TRI-COM BOARD OF DIRECTORS SPECIAL MEETING
Special Meeting Agenda
Friday, September 20, 2019

Change Order No. 2

Project Name: STARCOM21 Conversion Project

Customer Name:	Tri-Com Central Dispatch						
Equipment Location	3823 Karl Madsen Drive, St. Charles, IL 60175						
Requestor:	Debra Brown			Project #:		TBD	
Inspector's Name:	Michael Barton			Audit Date:		August 5th, 2019	
Site Name:	Central Dispatch						
Motorola Pass/Fail	Pass	33	Fail	12	N/A	95

PBB earth grounding connection.

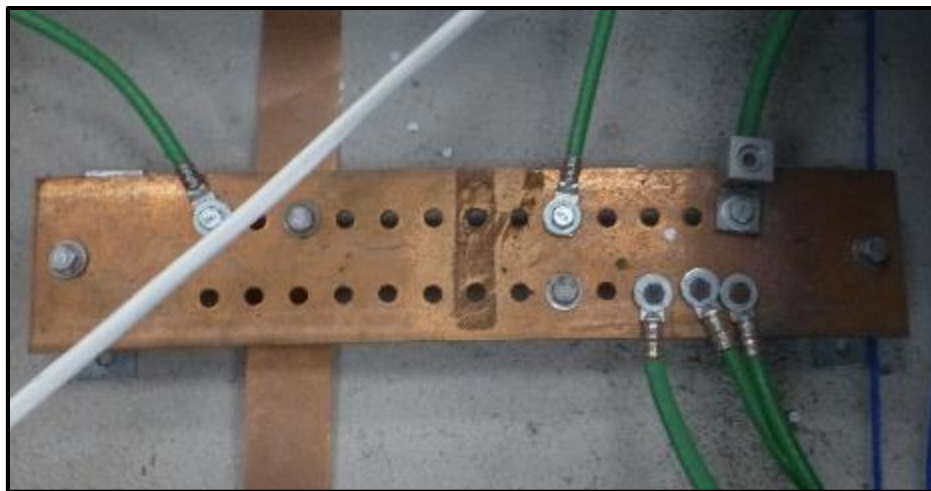
- 4.b: The PBB grounding electrode conductor has not been properly bonded by approved connection methods. It is attached to the PBB with a mechanical lug. Lugs equipped with mechanical set screw securing hardware for conductor connection shall not be used on bonding/grounding conductors. Single hole lugs are not permitted. The PBB grounding conductor shall be secured to the PBB by exothermic welding, listed compression two-hole lug, or irreversible compression-type connection device. The earth grounding conductor is attached to the earth grounding conductor with a split bolt. Split Bolt connection devices shall not be used to bond ground conductors. The PBB grounding electrode conductor shall be free of splices. Should a splice become necessary, splicing shall be permitted only by exothermic weld or listed irreversible compression-type connection. Grounding electrode system connections shall be joined using exothermic welding or listed irreversible high-compression fittings *Reference R56, Paragraphs 5.6.1.4 & 5.6.1.6.*

Examples of ancillary secured to the perimeter bus in the wrong direction.

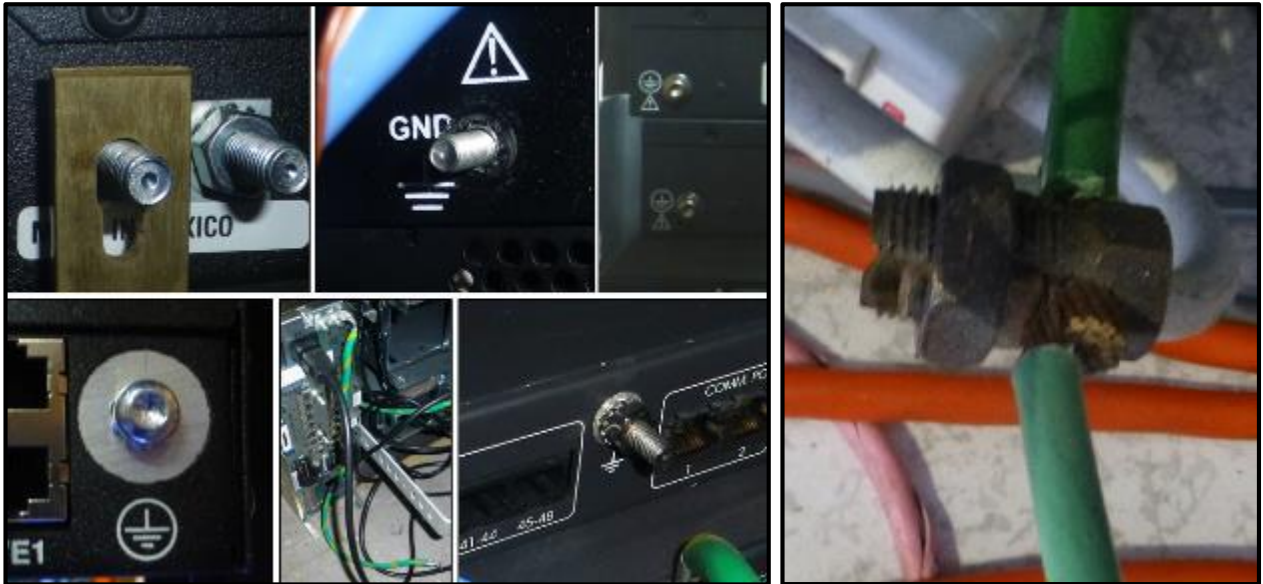
- 4.r: Not all ground bus conductors, ground bus extensions and equipment grounding conductors are routed towards the PBB, RBB or SBB as required. Multiple pieces of ancillary equipment is secured to the perimeter bus conductor in the wrong direction - flowing away from the ground source. Grounding conductors shall be run as short, straight, and smoothly as possible, with the fewest possible number of bends and curves. All bends and curves shall be made toward the ground location. The main reason is because the perimeter bus is bonded to ground with multiple down conductors. *Reference R56, Paragraph 5.6.6.3.*

Individual chassis equipment not bonded.

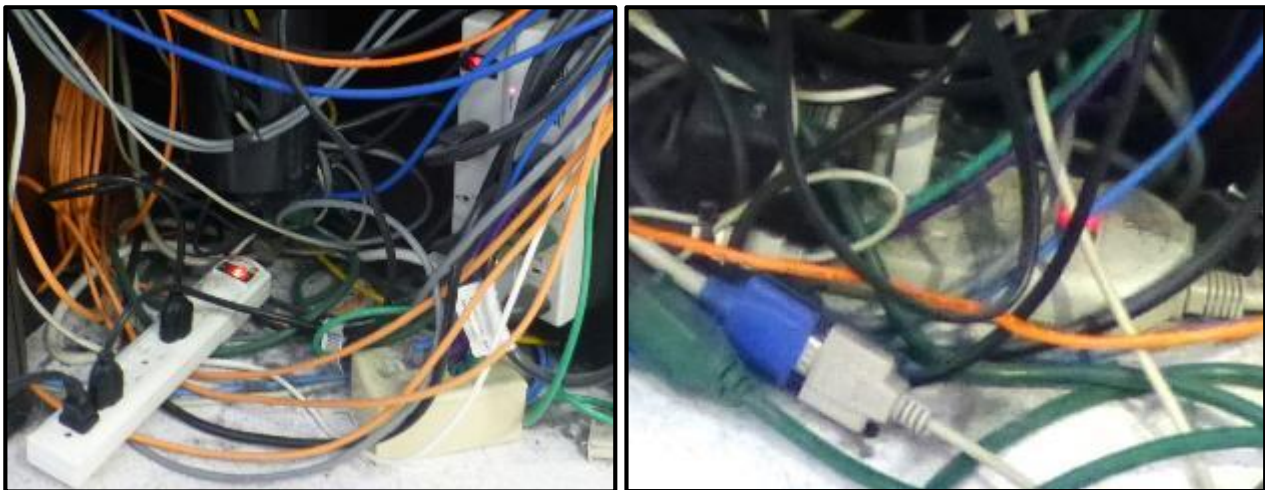
- 4.w: Individual system component chassis equipment is not properly bonded as required. On equipment where a ground stud or connection point is provided by the manufacturer a #6 AWG or coarser equipment grounding conductor shall be attached to this attachment point and bonded to the RBB, equipment grounding bus conductor or other suitable grounding point. The NBB shall be attached directly to each equipment chassis with suitable stainless-steel hardware. (Shown are an improperly attached NBB, existing APX installed in rack with new APX Consolettes, LAN switches, GGM 8000, SDM and GCP 8000.) There is other existing/older equipment not properly bonded. The VPMs at the dispatch positions are secured to bonding conductor with split bolts. Split bolts are not permitted. Some of the above was existing and some will be replaced. *Reference R56, Paragraphs 5.6.6.8 & 5.9.1.5.*

Cabling not installed to standards.

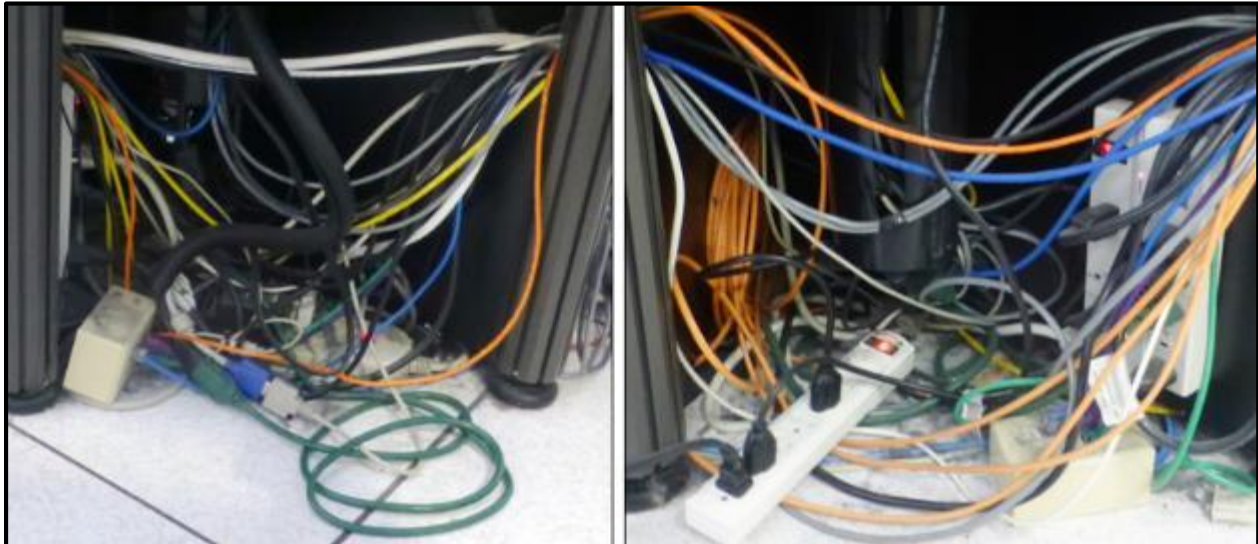
- 7.f: Cables and cable groups of different function do not maintain a minimum 2-inch separation as required. Cable groups shall be separated by 2 inches from other cable groups. All ground conductors shall be separated a minimum of 2 inches from conductors of other cable groups. Transmission lines (coax) for transmitting stations shall be separated a minimum of 4 inches from electrical lights, power, and signaling circuits. *Reference R56, Paragraphs 9.9.1.5 & 9.9.3.2.*

- 7.n: CAT-5 cables do not maintain the proper separation from AC power cables. Avoid routing CAT 5 cable near sources of EMI/RFI. Routing cables near sources of EMI/RFI can cause data errors and degraded system performance. Cables shall be separated by at least 2 inches from AC power conductors. Such noise sources may be electrical power wiring, dimmer switches, radio frequency transmitters, motors, generators, and fluorescent lights. Doing so can be unsafe and is likely to cause EMI onto the CAT 5 cable, causing network errors. *Reference R56, Paragraph 9.9.6.4.*
